Service Bulletin SB.JS-002

3 July 2012

Landing Gear Linkage System Adjustment

MODEL	SERIAL NUMBERS
JS1A	001 to 003, 005, 009
JS1B	004, 006 to 008, 010 ONWARDS

Figure 1 Landing Gear Linkage Elements

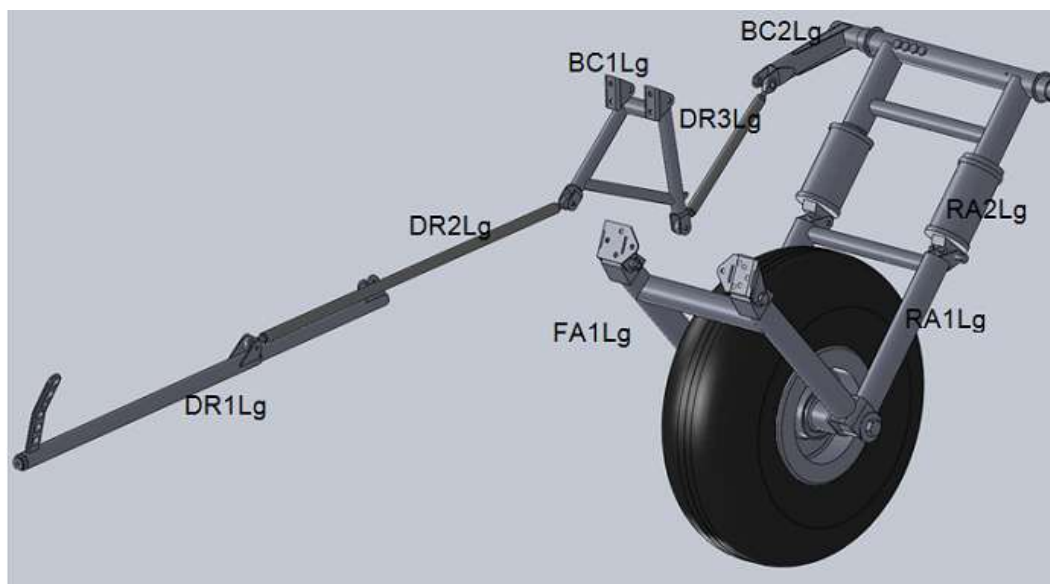
A report was filed where the landing gear of a JS1 collapsed during landing on a rough field. Further investigation showed that the probable cause was due to play in the landing gear linkage system when it was locked in the down position.

1. Place fuselage on a fuselage cradle and ensure it is safe to retract the main wheel.
2. Lock main wheel in down position and ensure the main wheel is off the ground.
3. Put hand on rear landing gear arms (RA1Lg and RA2Lg) and feel if there is any play on the hinge in the rear arm. This is the hinge above the shock element that folds during retraction.
4. Approximately 3mm of play is normal, but the landing gear lock should hold the wheel rear arms in the locked position. The possible play should be countered by the lock in the cockpit and the play should only be due to the elasticity in the system.

In the case of excessive play, the links must be adjusted according to Procedure 1.

1. Remove seat pan.
2. Remove the M6 bolt that connects the landing gear handle DR1LG to DR2LG
3. Turn in the rod end on DR2LG, with half turn increments. Install the bolt again and check if the landing gear rear arm play is removed.
4. If all the play can be removed by this adjustment, then the procedure is done.
5. Reinstall the M6 bolt with a new locknut.
6. Reinstall seat pan.

Figure 2 Linkage Elements Behind Bulkhead B5

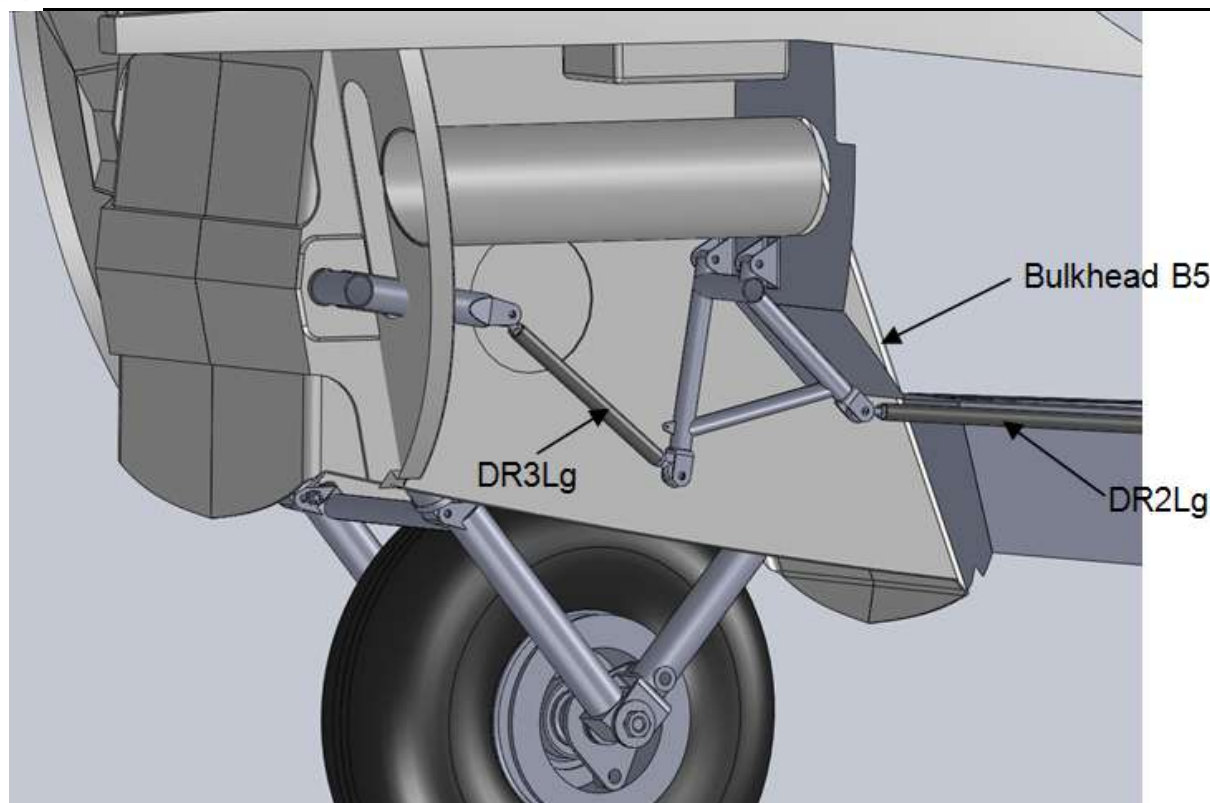
If the play cannot be removed with the adjustment of DR1LG then follow Procedure 2.

1. Open inspection hole in right-hand wall of wheelbox. If this inspection hole was not made during manufacturing it can be cut now. Refer to the procedure below.
2. Remove the M6 bolt connecting the landing gear handle DR1LG to DR2LG in the cockpit.
3. Put the landing gear handle in the locked down position.
4. Adjust the rod end on DR2LG so that BC1LG is just shy of touching Bulkhead B5.
5. Adjust the rod end on DR3LG inwards so that the play in the landing gear when locked, is removed. DR3LG is accessed through the inspection hole in the wheelbox side.
6. Reinstall all M6 bolts with new nylock nuts.
7. Replace the cover plate on the wheelbox inspection hole.
8. Reinstall seat pan.
